**PUBLIC INTEREST REVIEW FOR GROUNDWATER APPLICATIONS**

TO: Water Rights Section Date 02/23/2015  
 FROM: Groundwater Section Michael Thoma / Gerald Grondin  
Reviewer's Name  
 SUBJECT: Application G- 17858 Supersedes review of July 29, 2014  
Date of Review(s)

**A. GENERAL INFORMATION:** Applicant's Name: Tom and Lynne Hill Trust County: Baker

Figure 2: Application Overview Map

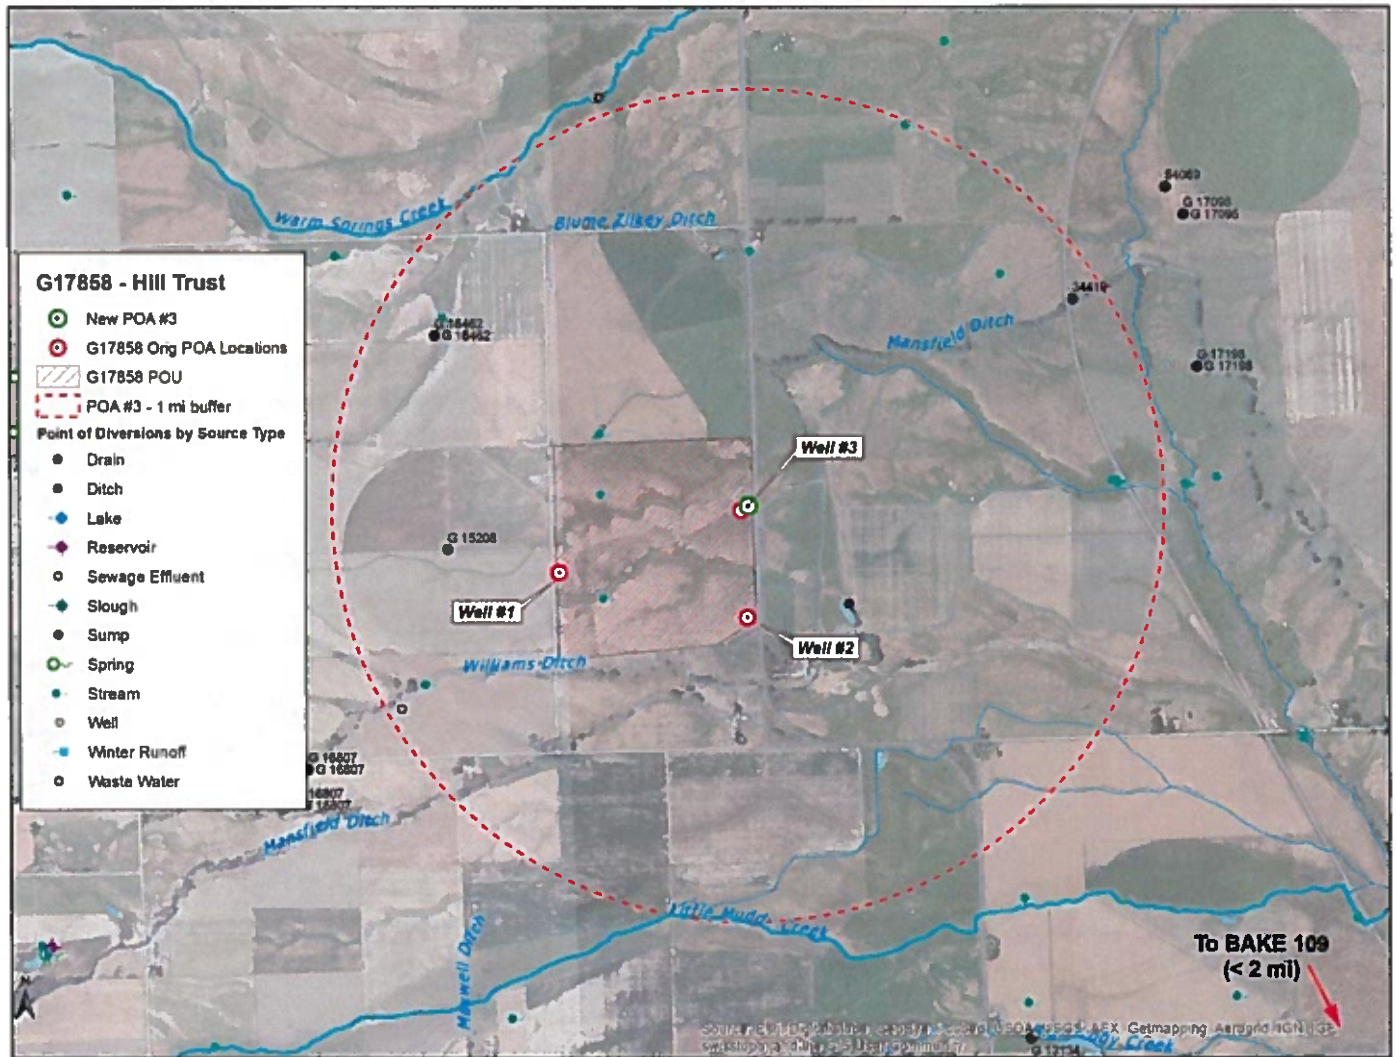
**Regarding Appropriation:** A nearby state observation well (BAKE 109; 316 ft total depth; Figure 2) shows stable water levels from 1960-present and other reported water levels in the area also show stable water levels which indicate that groundwater has not historically been over-appropriated. However, several permits have been issued recently in the vicinity of this applicant's proposed POAs that have not been fully exercised (either currently under extension of have not reached completion date, but most have not begun reporting water use). Within a 3 mi radius of the proposed POAs there are permitted rights for > 3000 acres of supplemental irrigation and nearly 1000 acres of primary irrigation (permit G17095: 995 acres primary irrigation). Although these are mostly supplemental irrigation rights, were they all to be exercised, there is potential for over-appropriation of groundwater which could lead to declining water levels. Hence standard drawdown conditions are appropriate and need be enforced.

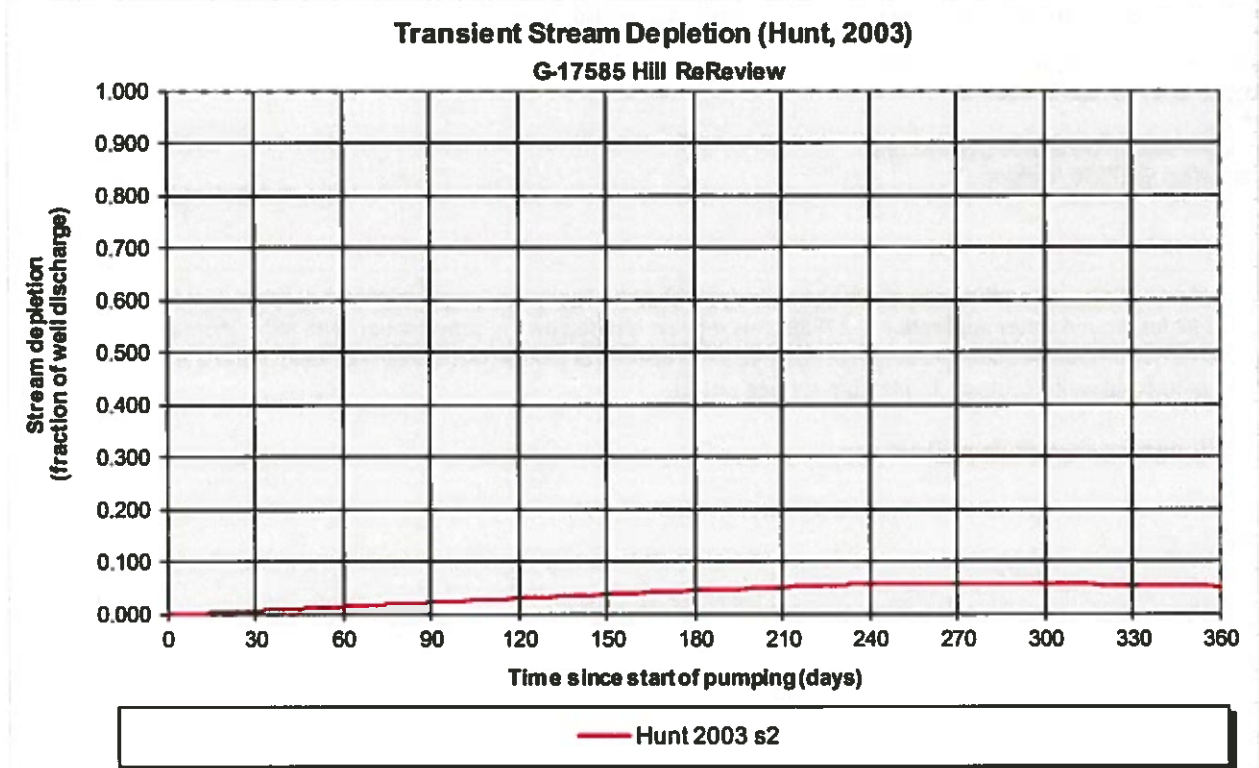
**Basis for aquifer hydraulic connection evaluation:** Although the proposed well will likely encounter confined conditions, comparison of SWLs from shallow and deep wells in the vicinity show little difference in water level (Figure 3). This implies that there is connection between deeper and shallower portions of the aquifer. The shallow portion of the aquifer (the thick, low-permeability, clay layer and upper coarse sediments) is likely hydraulically connected to surface water sources but the hydraulic properties of this material (low hydraulic conductivity) will limit the efficiency of the connection. Moreover, because there are several surface water rights on both the Little Muddy and Warm Springs creeks and because of historically low to dry late-season flows in these creeks, using a conservative approach to hydraulic connection (i.e. one that will produce the least potential injury to existing water rights) is appropriate.
